## SIB 51 21 20

### RECALL 20V-379: TOP TETHER ANCHOR COVER

2020-07-09

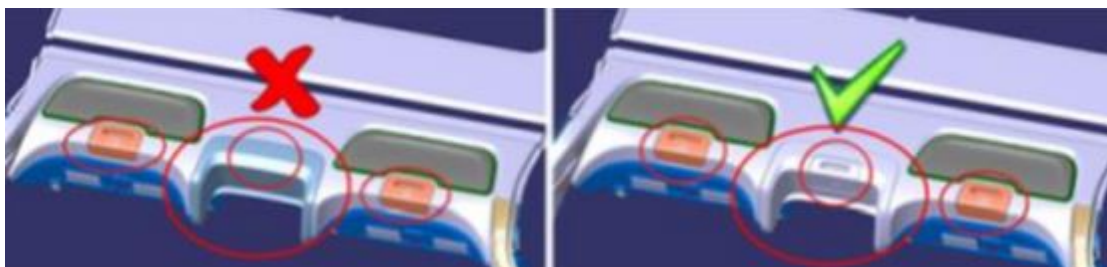
The top tether anchor at the rear center seating position, may not be accessible. If a child seat was placed on the rear center seat, the child seat's top tether would not be able to be attached to the vehicle.

An incorrect trim panel was installed during production.

1. Inspect the trim panel above the center arm rest, in the area of the rear parcel shelf (area circled below). Does the trim panel have a tether cover as shown? Note: No trim panel tether cover on left (bad). Trim panel tether cover is in place on right (OK).

Inspect the armrest trim and the top tether cover. Replace if necessary.

If trim panel tether cover is installed, no further correction is required.

If trim panel tether cover is not installed, continue to step 2.

2. Replace the top armrest trim **and** tether cover. Repair instructions are included within **REP 52 25 280 “Removing and installing the center armrest”**.
